CITY OF ALBUQUERQUE

**RE: 5730 McMahon Blvd NW –McMahon Market Place New Shell Building
Grading Plan
Stamp Date: No Stamp Date
Hydrology File: A11D011E**

THE PROPERTY WILL FREE DISCHARGE AFTER FIRST FLUSH RETENTION IS ACHIEVED.

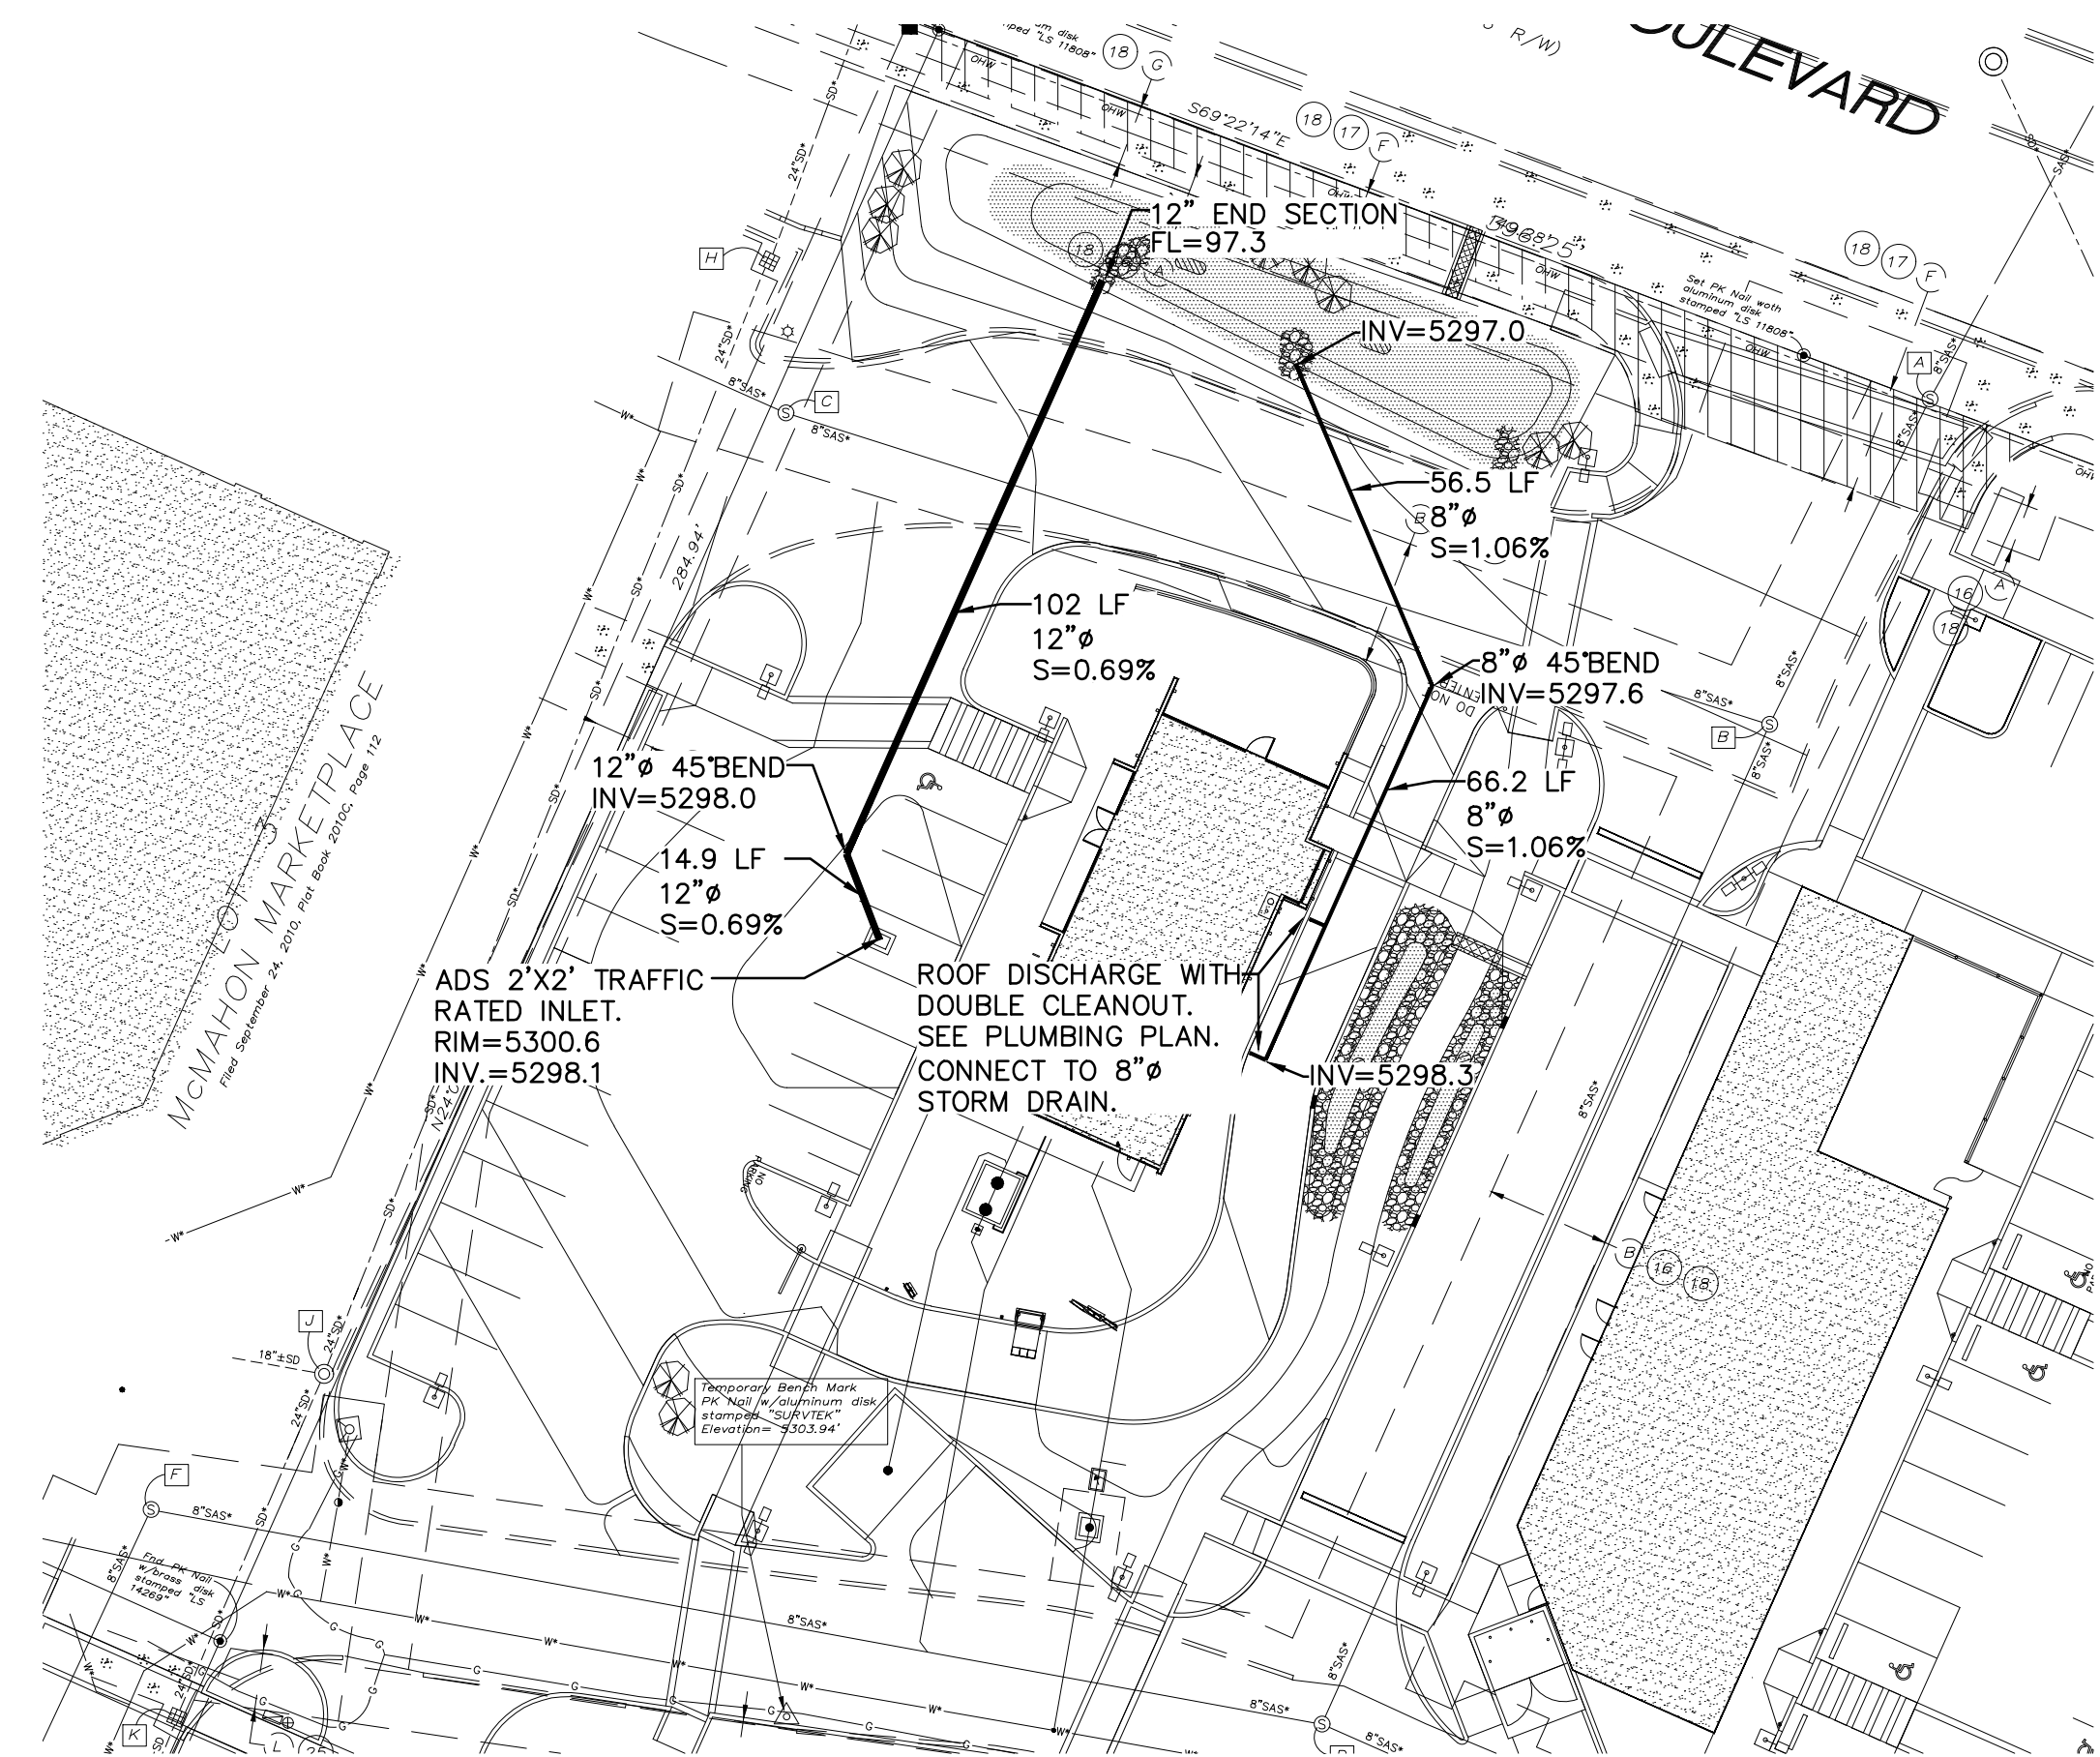
1. On Sheet CG-1 & CG-2. Please provide an engineer's stamp with signature & date.

8. On Sheet CG-1. There are easements shown. Please label the easements.
9. On Sheet CG-2. Under the Drainage Plan Concept, The McMahon Marketplace DMP is called out. This plan used 5% Type B, 10% Type C, and 85% Type D. This plan also calls for the commercial tracts are permitted free discharge as long as the future development detains the 8.4 cfs for the entire 12.13 AC McMahon Marketplace in either a pond or change the amount of landscaping (Type B) and impervious (Type D) amounts. The Unser/McMahon Area DMP, 2001 by Bohann-Huston calls for 90% Type D and 10% Type B. Please update this section. **This site will be able to free discharge under the McMahon Marketplace DMP,** however Lots 5-A, 6-A, 8-A, 9-A, 9-B, 9-C, and 9-D will have to follow the McMahon Marketplace DMP and detain the 8.4 cfs in a pond.

10. On Sheet CG-2. Please provide the weir calculations for the 24"; curb cut.
11. On Sheet CG-2. Please provide the weir calculations for the sidewalk culvert.
